Special Bulletin

SP16-302A

PRESSURE CAP REPLACEMENT

Prevost vehicles

Figure 1

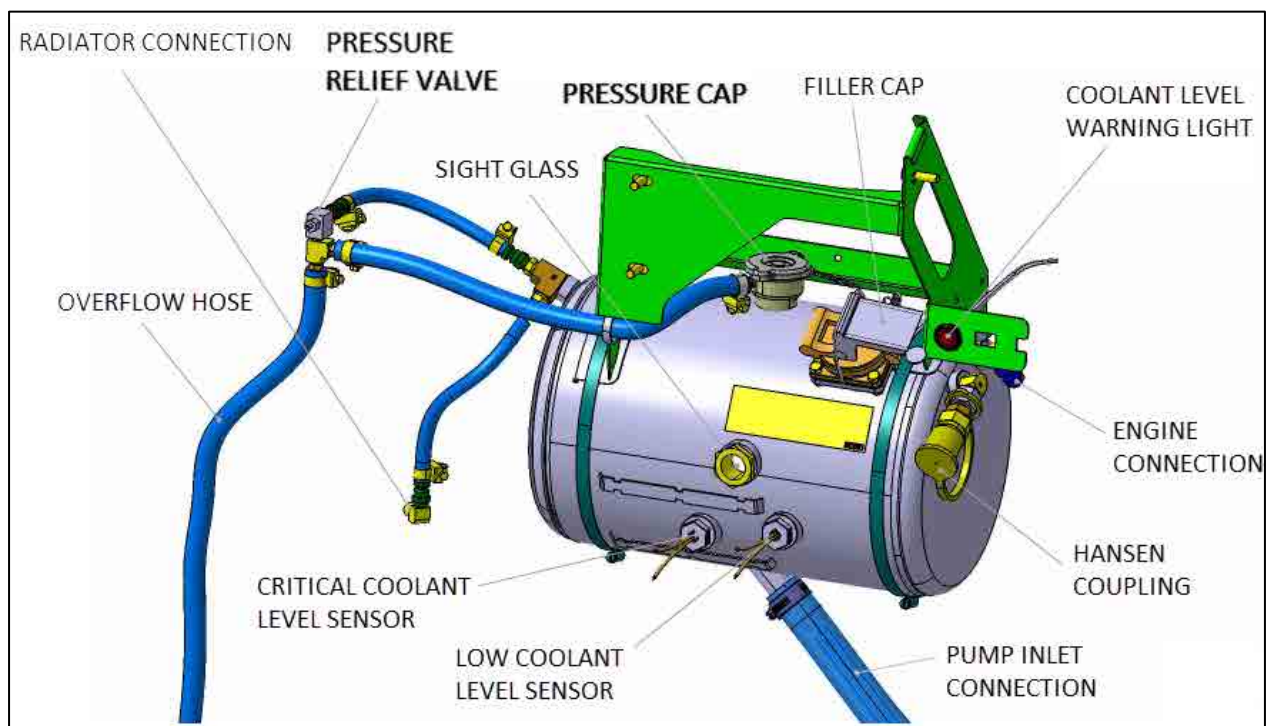
1. Relieve cooling system pressure by depressing the pressure relief valve button, left of the surge tank.(Fig. 1)
2. *Heed the safety warning above.*
3. Unscrew the pressure cap from the surge tank.

Figure 3 (image for reference only)

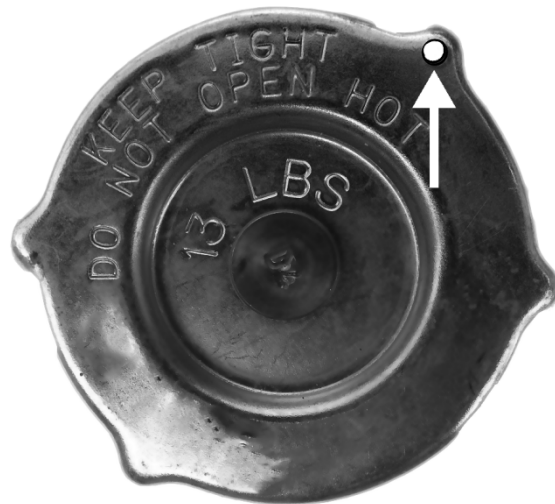
5. On the new cap head, drill a **3/16"** hole on one prong. Choose a similar location as the original cap. (Fig. 3)
6. Install the “S” hook in the newly drilled hole and bend the “S” hook closed with pliers.
7. Install the new cap on the surge tank.
